August 6, 2015

Subject: THP 1-15-042 SON (Gualala Redwoods Inc. "Dogwood" THP)
THP 1-15-033 SON (Gualala Redwoods Inc. "Apple" THP)

I have reviewed the THPs and an associated report entitled, "Hydrologic Assessment of Water Withdrawal for Dust Control Use", prepared for Gulalala Redwoods, Inc. by O'Connor Environmental, Inc. (OEI) and dated June 11, 2010. The OEI report concludes that surface water drafting from the South Fork Gualala River for dust control purposes will not adversely impact summer rearing habitat for steelhead. Based on my review, I believe the OEI analysis is flawed and grossly underestimates the potential impacts on steelhead summer rearing habitat in the river due to surface water drafting. I don't believe the OEI study has correctly evaluated potential impacts on steelhead and

FIGURE 1: Chronology of average unit area discharge rates for the July through September period derived from USGS flow monitoring data. Discharge expressed in cubic feet per second (cfs) per square mile of drainage area.

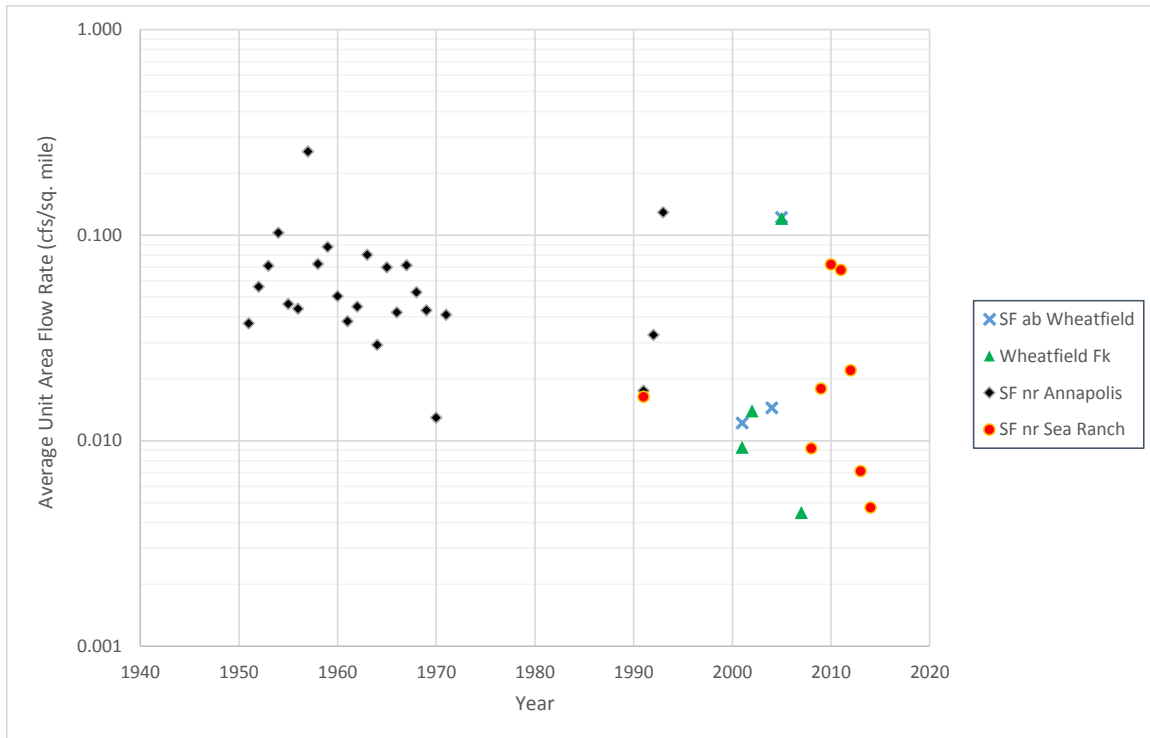
When comparing the average flow rate for the full summer period (July-September) versus the average flow rate for each individual month, it can be seen that the July-September average flow rates (columns G [unit area] and K [scaled area]) are almost always greater than the individual average August and September flow rates (columns D-F [unit area] and H-J [scaled area]) during the vast majority of years analyzed. Thus, the use of a full summer (July-September) flow rate by OEI in their hydrologic analysis grossly overestimates the amount of water actually being delivered to the proposed water drafting site at the confluence of the South and Wheatfield Forks of the Gualala River during the August and September periods. Therefore, the baseflow rates used by OEI do not represent low flow conditions experienced during the majority of the summer period. In fact, if an analysis were completed on average daily flow data instead of monthly averages, it is likely that the minimum daily flow rate experienced during any given year would be even lower than the average monthly flow rate for coincident periods. The waning days of late summer, when flows are at their lowest and river pools becomes disconnected (esp. during dry years), represents the period of greatest potential pumping impacts to pool water levels and associated aquatic habitat.

It is important to note that the average September flow rates (column c, Table 1) observed on the SF Gualala River during dry years (1991, 1992, 2008, 2009, 2012, 2013 and 2014) are very near or lower than the typical water drafting pumping rates reported by OEI at 100-300 gpm or 0.22 to 0.67 cfs. Thus, their statement that withdrawals represent less than 0.1% of the total daily flow for one truckload and less than 0.5% for five truckloads is grossly inaccurate for dry year periods when pumping rates are near or greater than available surface flows. Pumping at these rates could dewater pools and river during dry and possibly other year types.

Therefore, a more appropriate and conservative baseflow rate should be used in the OEI analysis such as the minimum daily flow rate for the entire summer low flow period – a value that is likely orders of magnitude lower than the average July-September flow rate actually used in the 2010 OEI analysis. Particular emphasis should be placed on using more realistic flow rates in the analysis due to the current decline in summer baseflow rates occurring on the Gualala River. This decline is illustrated by plotting a chronology of the unit area flow rates on the SF Gualala River from column G of Table 1 (see Figure 1). Although discussion for the decline in summer baseflow rates is beyond the scope of this letter, these data clearly indicate a trend of decreasing summer water supply that is adversely impacting summer rearing habitat for salmonids in the Gualala River.
